Addendum Number: 07

Addendum Issue Date: May 8, 2025

Project Name: Robinson Washington Elementary
Renovation & Addition

Project Number: 02401781.001

TYP DEMO PLAN AT EXISTING CLASSROOM WINDOWS

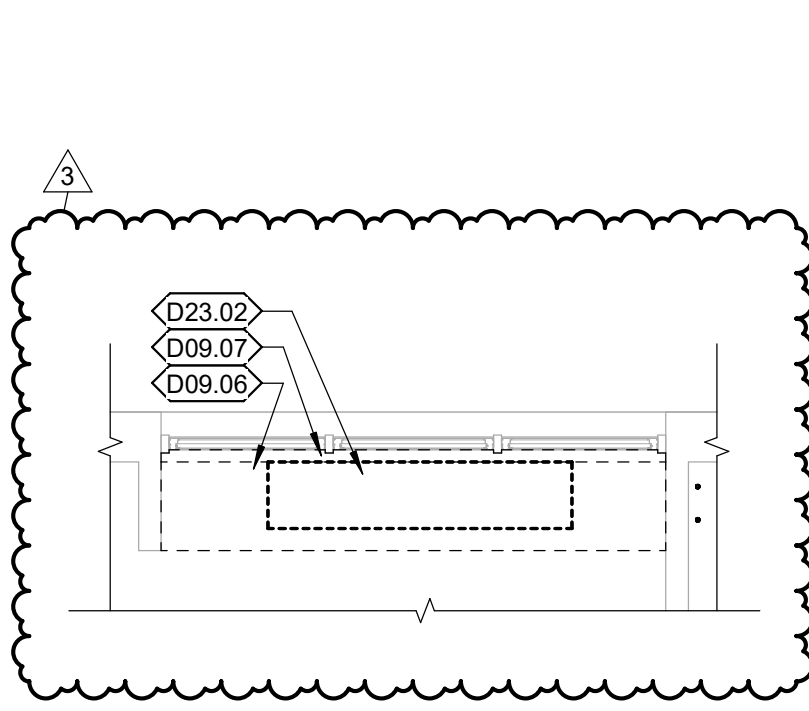
1. AD1.1 – DEMOLITION PLANS
 - a. ADD detail 6 showing the extents of demolition at all existing classroom windows. ADD keynotes D09.06 and D09.07 denoting to demolish existing carpet flooring and slate sill at existing classroom windows. See attached.
 - b. REVISE detail numbering on sheet to accommodate new detail. See attached.
2. A1.1 – OVERALL FLOOR PLAN
 - a. ADD callout for new detail 3/A7.5 as shown. See the attached.
3. A3.2 – EXTERIOR ELEVATIONS
 - a. REMOVE metal handrail and associated elevation keynote 25 from detail 4. Revision was included in addendum 04 but drawing sheet was omitted by mistake.
4. A7.5 – GLAZING DETAILS
 - a. ADD detail 3 showing new finishes to be installed at all existing classroom windows once unit heater demolition is completed. See attached.

TYP DETAIL AT EXISTING CLASSROOM
WINDOW

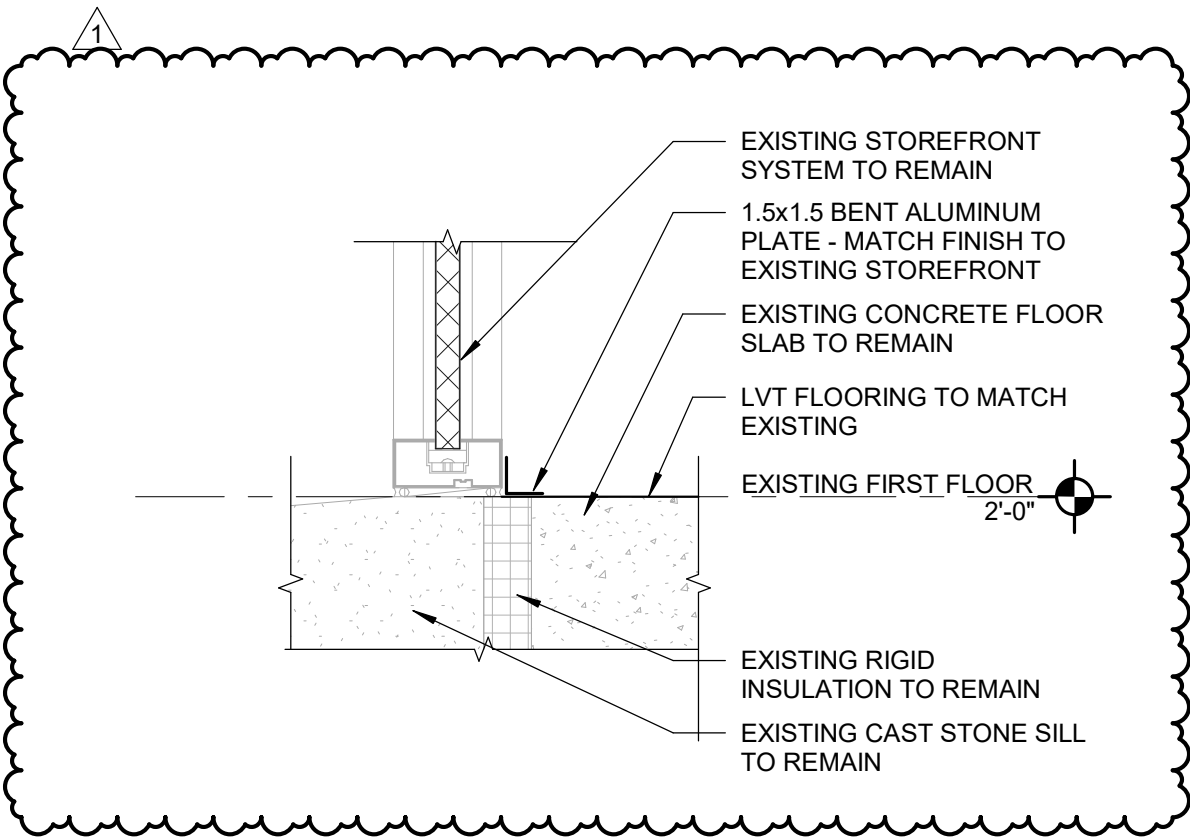
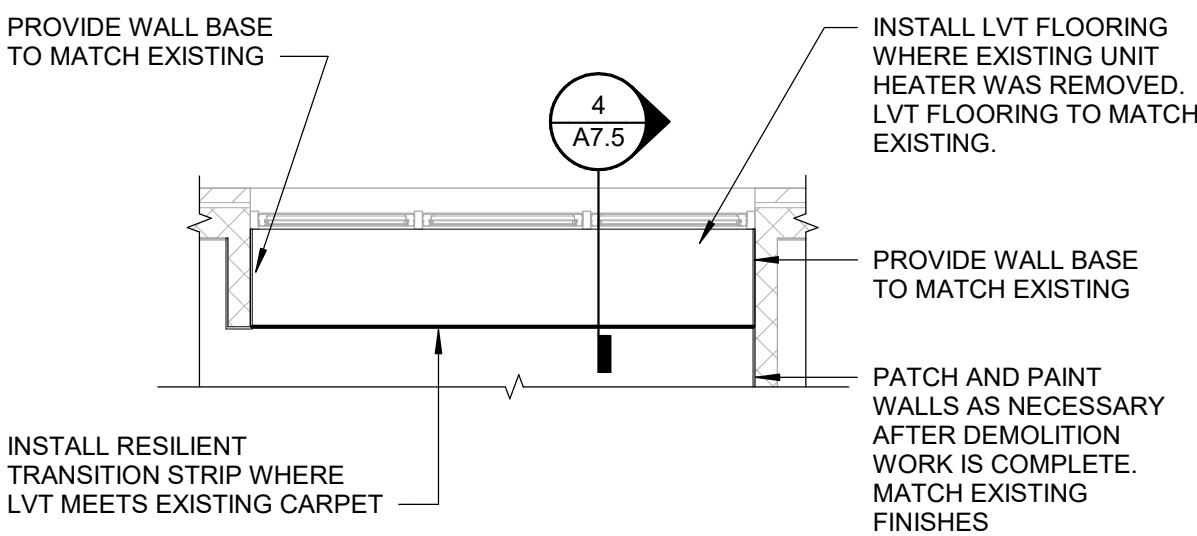
- b. ADD detail 4 showing sill conditions at all existing classroom windows. See attached.
- 5. E2.4 – ELECTRICAL ROOF PLAN
 - a. REVISE sheet scale. See the attached sheet.
 - b. REVISE bar scale. See the attached sheet.
- 6. E2.5 – TEMPORARY ELECTRICAL CONNECTIONS
 - a. REVISE sheet scale. See the attached sheet.
 - b. REVISE bar scale. See the attached sheet.
- 7. E4.1 – ONE-LINE DIAGRAM
 - a. REVISE feeder into MDP-B to include ground wire. See the attached sheet.
